SANITARY SEWER IMPROVEMENTS

PIKE ADDITION

CITY OF WICHITA, KANSAS

B. Woods - City of Wichita, Field Project Engineer
 Final Acceptance Date: 8/13/2021
 Completion Date: As-built
 : apr 4/21/2022

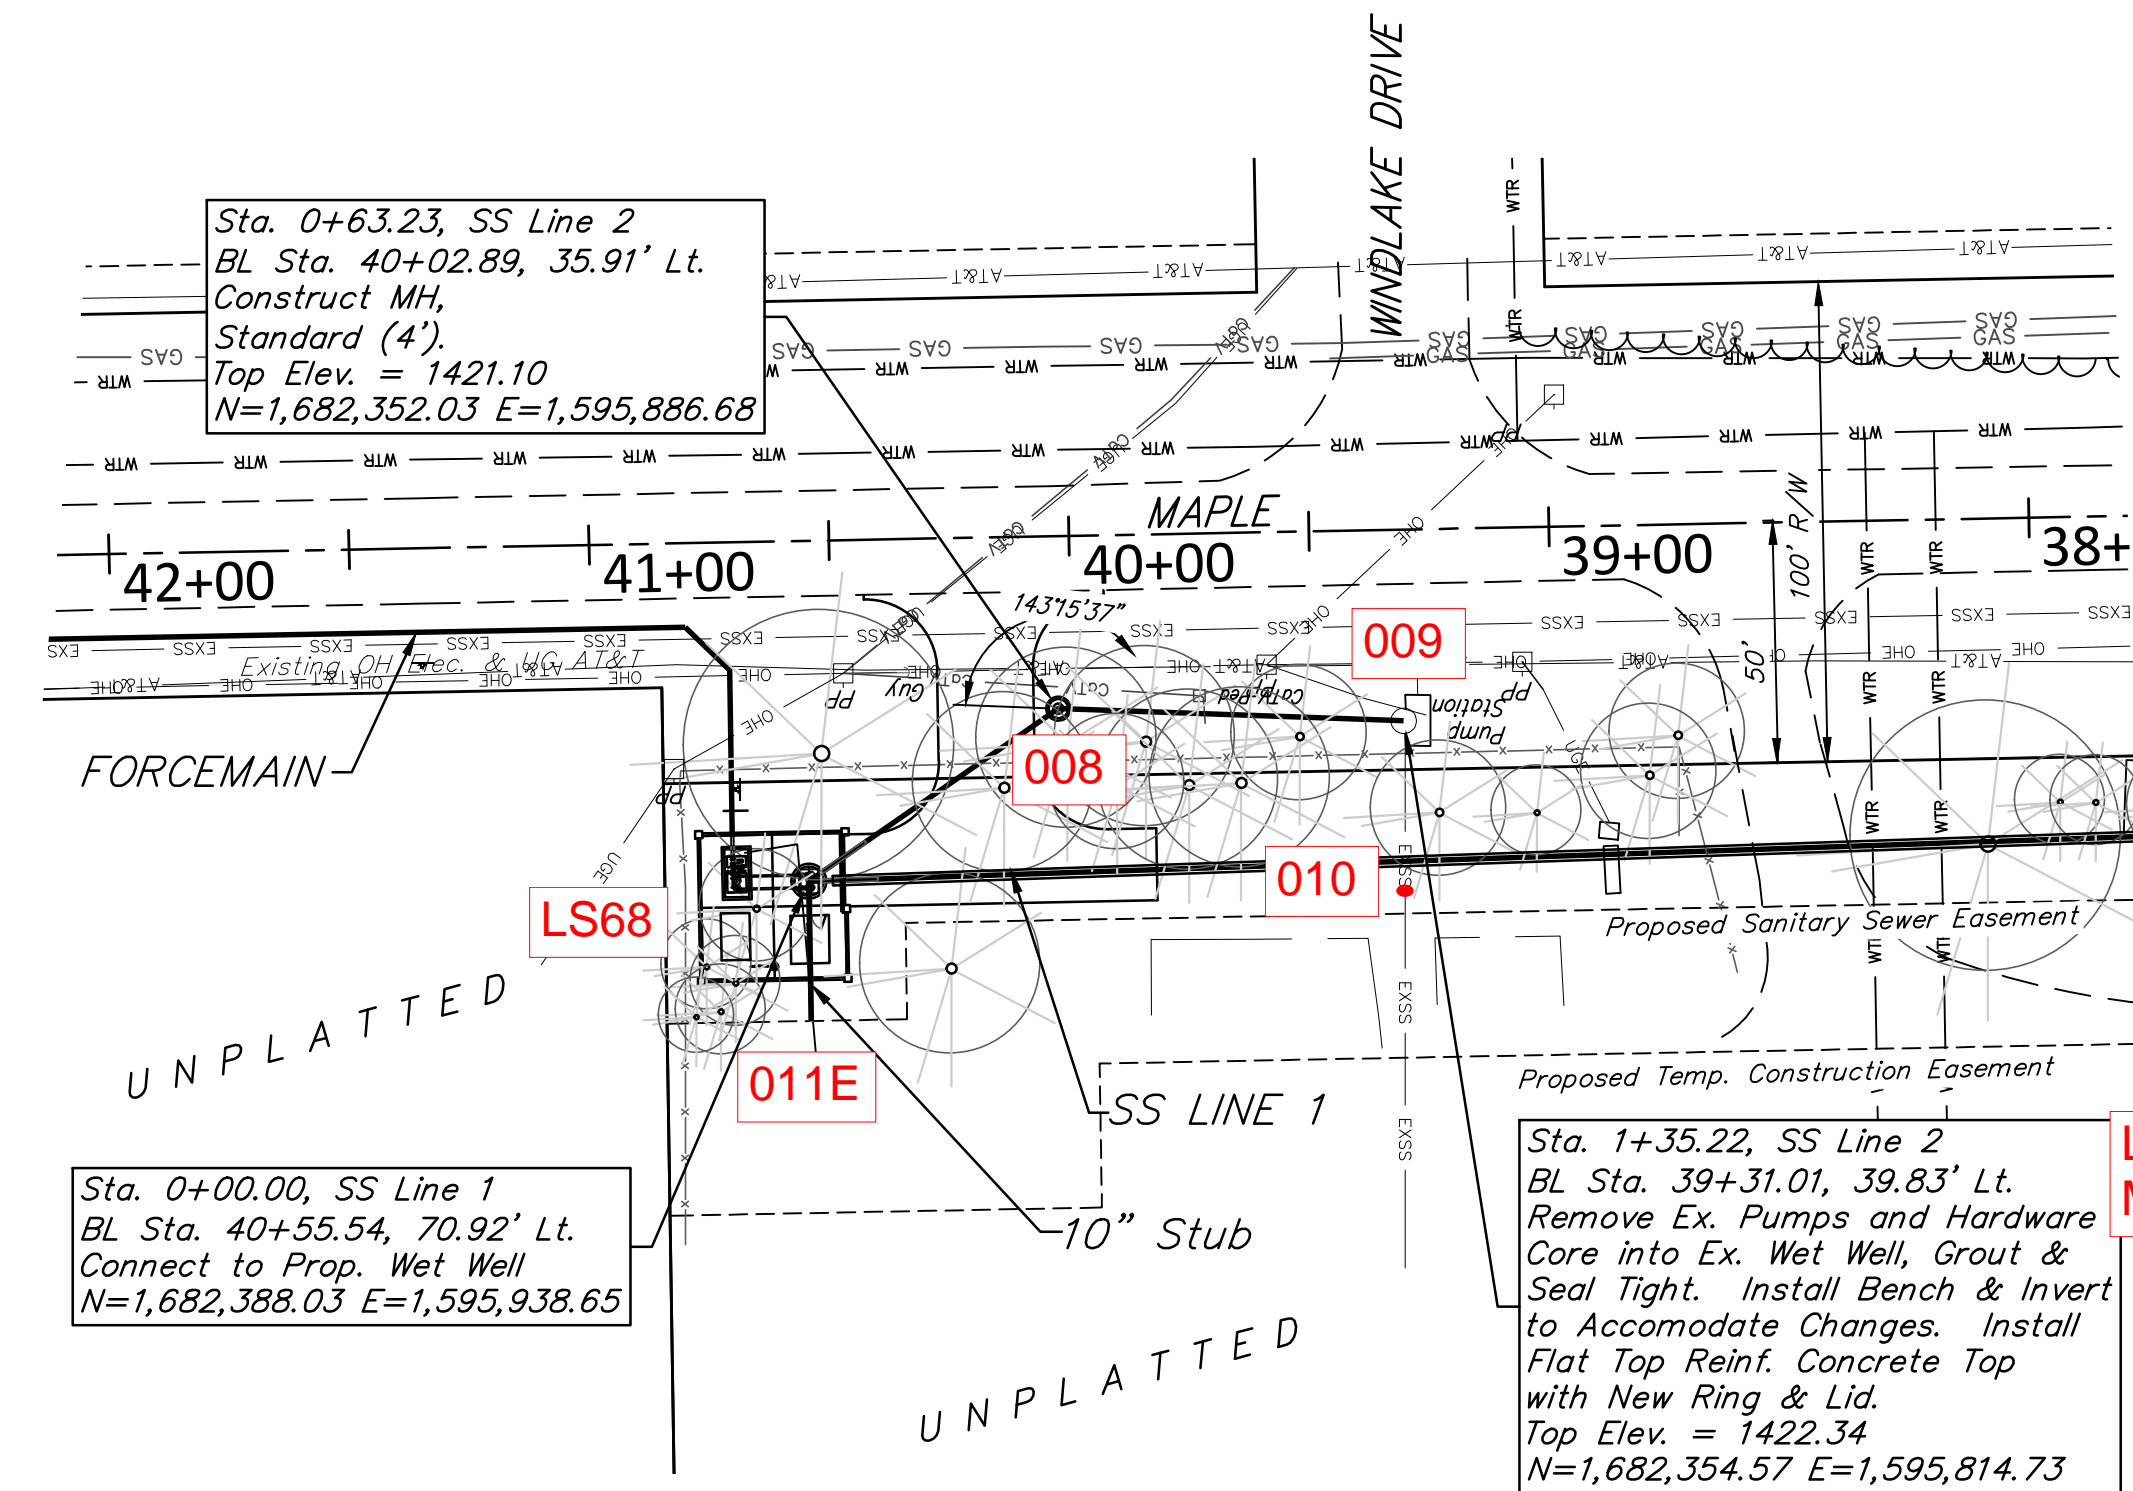
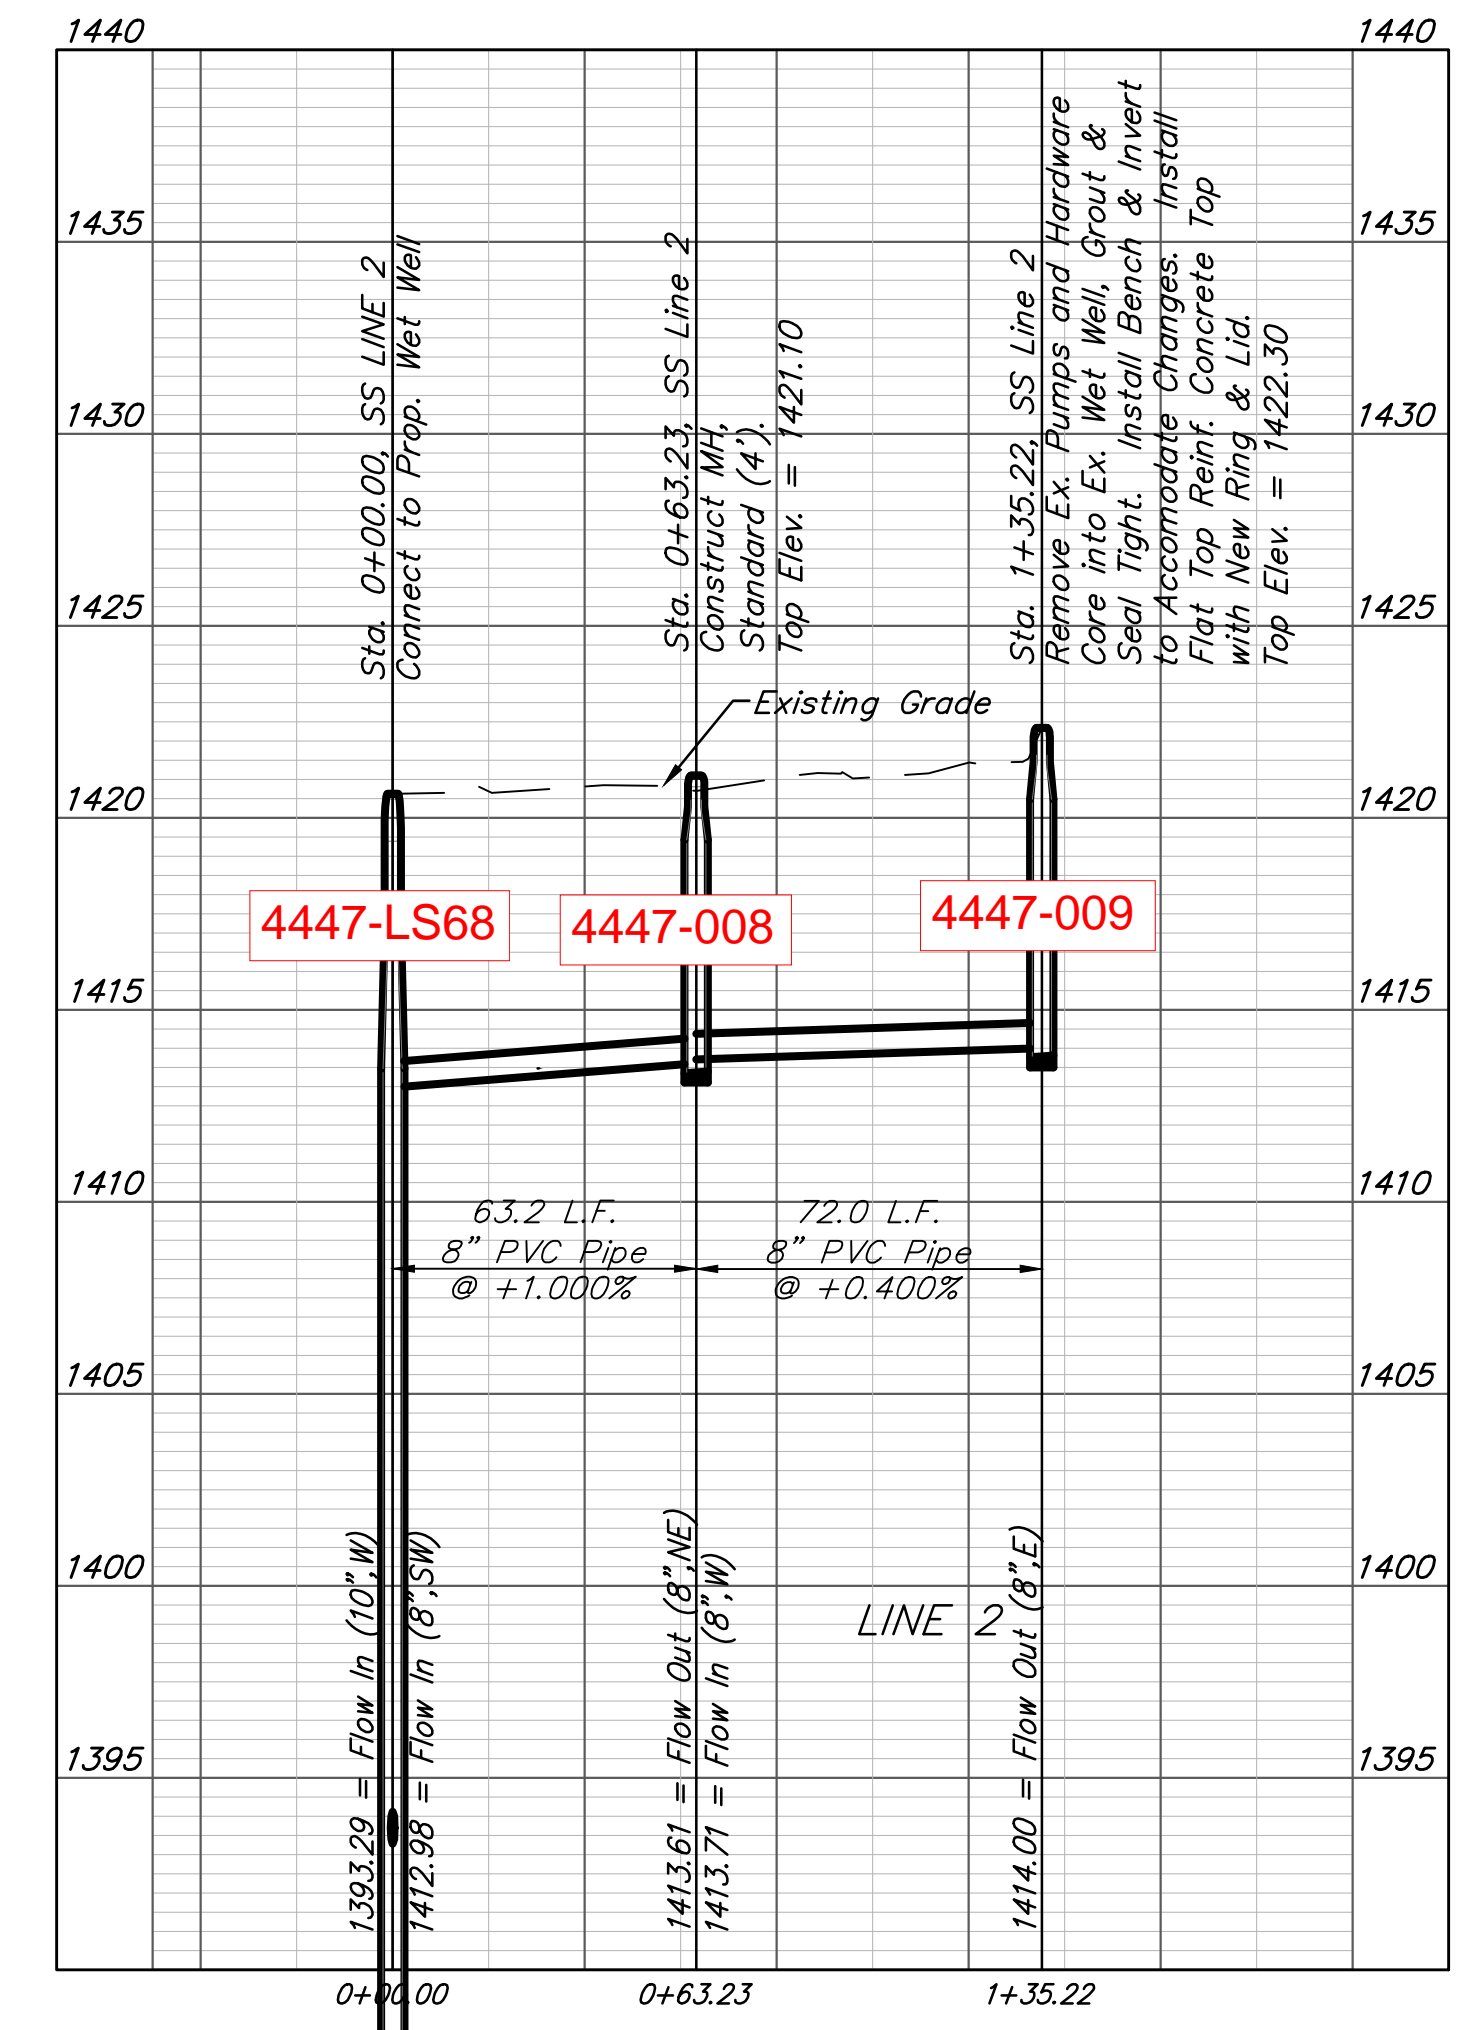
LS48 is now
 MH-009
